DRB Project Number: 2022-007063
Woodmont and Paseo del Norte

SI-2023-01044 - SITE PLAN DFT

REQUEST: SITE PLAN - ADMINISTRATIVE DFT FOR A 344 UNIT MULTI-FAMILY COMMUNITY CONSISTING OF MULTI-FAMILY, TOWN HOME, AND SINGLE FAMILY DETACHED RENTAL HOMES, WITH TWO AMENITY CENTERS WITH POOLS.

Planning - Case Comments

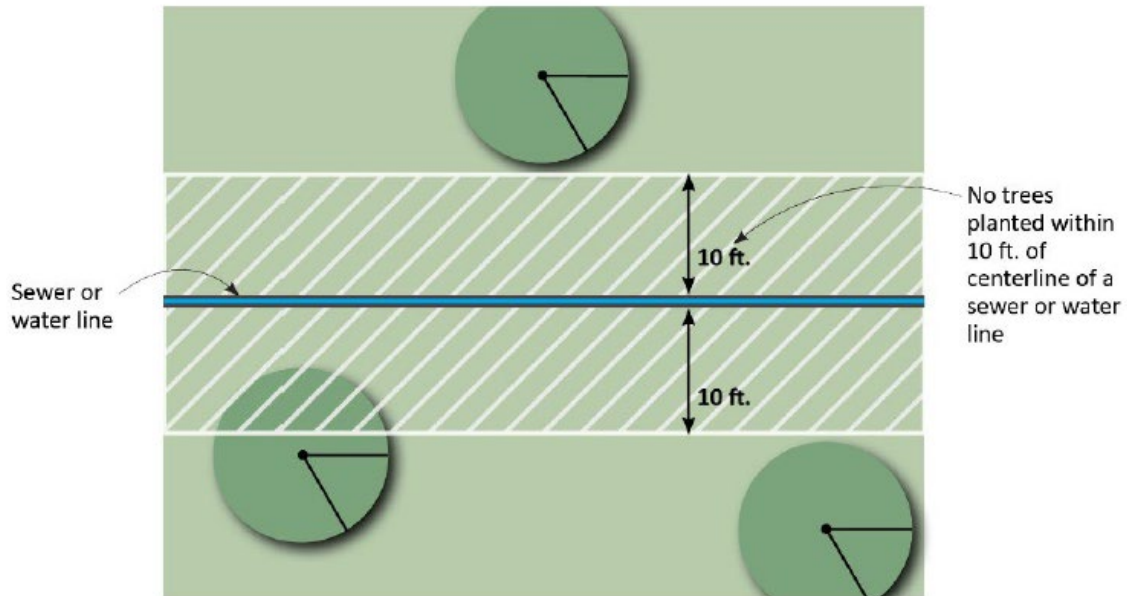
- Per 5-6(C)(10)(a) trees and shrubs shall not be planted in utility easements. **Please articulate how the proposed design meets this code.**
- Per 5-6(C)(10)(b) trees shall not be planted within 10 feet in any direction of the centerline of a sewer or water line. **Please show the sewer and water lines on the landscape plan and demonstrate how the proposed landscape complies with this code. See figure below from the IDO for your reference.**
